ENGINEERING DATA TRANSMITTAL

(A) Item No.	(B) Document/Drawing No.	(C) Sheet No.	(D) Rev. No.	(E) Title or Description of Data Transmitted	(F) Hard-copy or PDF	(G) Approval Desig-nator	(H) Reason for Trans-mittal	(I) Origi-nator Dispo-sition	(J) Receiv-er Dispo-sition
1	H-14-109933	1	0	Moisture Separator Dual Assembly	PDF	NA	1	1	1
				12" Inlet to 14" Outlet

TOC – INTERIM REVIEW COMMENT RECORD (RCR)

MOISTURE SEPARATOR DUAL ASSEMBLY 12" INLET TO 14" OUTLET

10 LABEL PLATE
SCALE: 1/2

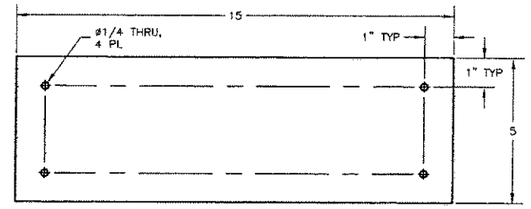
14. Item	15. Comments	16. Basis	16a. Category (a, b, c, d, e)	17. Recommendation	18. Reviewer Concurrence Required (Y or N)	19. Disposition (provide justification if NOT accepted)	20. Status
1	Provide access platform to reach all valves, obtain readings from DPI gages, obtain dose rates, and calibrate DPI gages.			Correct.		Acknowledged. Per management the means of access to the gauges will be provided using temporary platforms (i.e. scaffold).	C
2	Need to be able to access all valves and labels with shielding installed.			Correct.		Accept. Where feasible valves have been located outside the shielding.	C
3	Delete gas power skid sprayer and provide raw water distribution to all demister flush systems.			Correct.		Accept.	C
4	Each demister should be labeled separately instead of both being called DMST-001.			Correct.		Accept.	C
5	Why is the demister labeled with POR383? Shouldn't all the demister be preceded with AX241-VTP-DMST-XXX?			Correct.		Accept.	C

12. LOCATE IDENTIFICATION LABELING ON LABEL PLATE (ITEM 13) APPROXIMATE AS SHOWN. HANG LABELS WITH WIRE ROPE IN APPROXIMATE LOCATION AS SHOWN.
    TEXT CONTENTS: PORXXX-VTP-DMST-XXX, SEE H-14-020109
    TEXT TYPE: BLOCK
    TEXT MATERIAL: ACRYLIC ENAMEL
    TEXT COLORS BLACK ON YELLOW BACKGROUND
    TEXT: 1" HIGH CHARACTERS

1 MOISTURE SEPARATOR DUAL ASSEMBLY 12" INLET TO 14" OUTLET
SCALE: 1/12

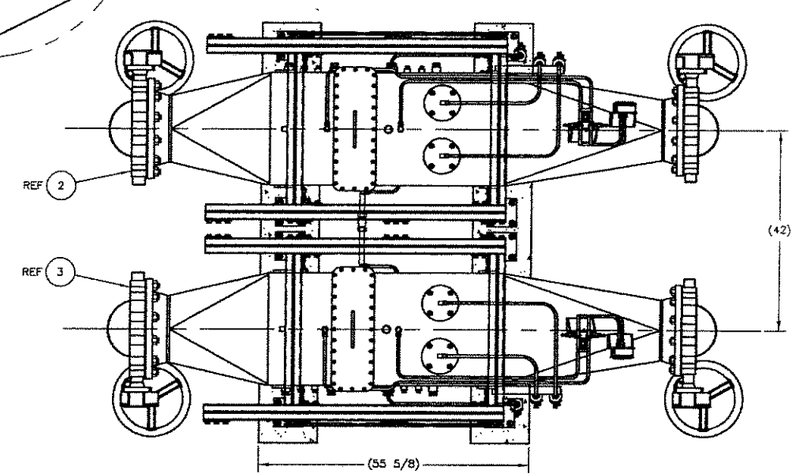
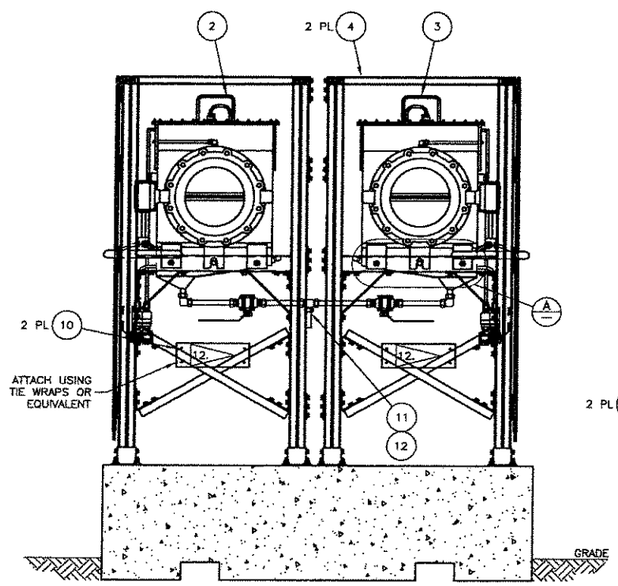
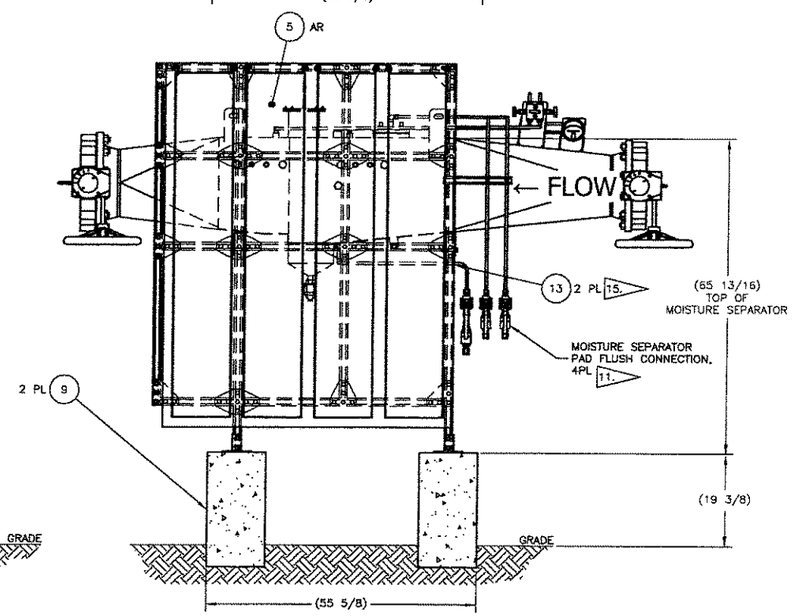
14. Item	15. Comments	16. Basis	16a. Category (a, b, c, d, e)	17. Recommendation	18. Reviewer Concurrence Required (Y or N)	19. Disposition (provide justification if NOT accepted)	20. Status
1	Note 13 does not test the unit in accordance with AG-1. Pressure decay test at 1.25X operating pressure and this is the biggest part. We will be doing a BYPASS flow test. This requirement will not be waived as it has been in the past. This is our only way of testing filter seating prior to installation in the farm.			Correct.		Accept.	C
2	Put in a note that special tooling, pry bars and or rubber hammers shall not be permitted for use while installing filter.			Correct.		Accept.	C
3	Consider removing the Fimco part number or say "or engineering equal" and stick to the requirements of the unit to adequately flush the system. This unit is not actually part of the moisture separator, so it's			Correct.		Accept. Replaced with note establishing flow and pressure requirements for a flush cycle.	C

14. Item	15. Comments	16. Basis	16a. Category (a, b, c, d, e)	17. Recommendation	18. Reviewer Concurrence Required (Y or N)	19. Disposition (provide justification if NOT accepted)	20. Status
1	Delete gas powered skid sprayer and provide raw water distribution to the demister skids. Including fuel powered equipment in a permanent design might lead us into further permitting activities for environmental compliance.			Correct.		Accept.	C
2							
3							
4							
5							
6

14. Item	15. Comments	16. Basis	16a. Category (a, b, c, d, e)	17. Recommendation	18. Reviewer Concurrence Required (Y or N)	19. Disposition (provide justification if NOT accepted)	20. Status
1	Change note 17 to note 11 for item 10, Gas Powered Skid Sprayer.			Correct.		Accept. Deleted gas powered skid sprayer.	C
2	Two item 10 on, Gas Powered Skid Sprayer.			Correct.		Accept. Deleted gas powered skid sprayer.	C
3							
4							
5							
6

10. INSULATE PER H-14-109924 NOTE 13 AFTER HEAT TRACING.
11. PAD FLUSH NOZZLES SHALL BE SUPPLIED WITH PORTABLE WATER FOR DECONTAMINATION FLUSHING. SOURCE SHALL BE CAPABLE OF SUPPLYING 4 GALLONS PER MINUTE AT A PRESSURE OF 150 PSI FOR EACH MOISTURE SEPARATOR. FLOW SUPPLY SHALL BE CAPABLE OF MAINTAINING FLOW AND PRESSURE REQUIREMENTS FOR A MINIMUM OF 10 MINUTES.
